NO.	REVISIONS	DATE	DESIGN	CHECK
03	ISSUED FOR ADDENDUM 3 - 976-2016	2017/06/21	B.C.	J.C.
02	ISSUED FOR CONSTRUCTION - 976-2016	2017/04/05	B.C.	J.C.
01	ISSUED FOR CONSTR - B.O. 899-2015	04/2016	B.C.	J.C.
00	ISSUED FOR TENDER - B.O. 899-2015	01/2016	B.C.	J.C.

SOUTH END WATER POLLUTION CONTROL CENTRE
SEWPC UPGRADING/EXPANSION PROJECT
PROCESS
BIOREACTORS/BLOWER BUILDING
BLOWER ROOM PLAN AND DETAIL

CITY DRAWING NUMBER: 1-0102-PGAD-R013
SHEET: 001
REV.: 03
SIZE: A1

BLOWER ROOM PLAN
1:50

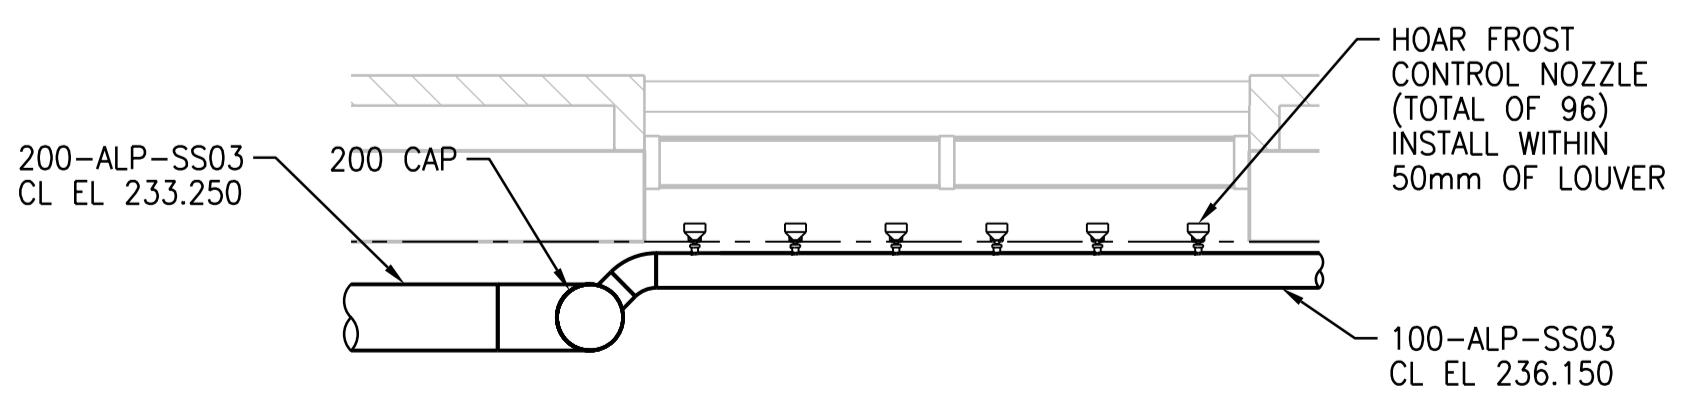
- NOTE:**
- CASE 1. BLOWER ENCLOSURE REQUIRES COOLING THROUGH DIRECT PIPING FROM OUTSIDE AIR: PROVIDE PIPING AS SHOWN BUT OMIT THE 450 MM DIAMETER 600 MM IN LENGTH INTERCONNECTION BETWEEN THE PROCESS AIR INTAKE AND THE ENCLOSURE AIR INTAKE.
 - CASE 2. BLOWER ENCLOSURE COOLING IS COMMON WITH PROCESS AIR INTAKE: OMIT THE 300-ALP-SS03 PIPE TO ENCLOSURE COOLING DOWNSTREAM OF A BLIND FLANGE TO BE INSTALLED WHERE SHOWN.
- IN BOTH CASES, INTAKE FILTER SILENCERS TO BE ALL INSTALLED AS SHOWN. TOTAL OF 12.
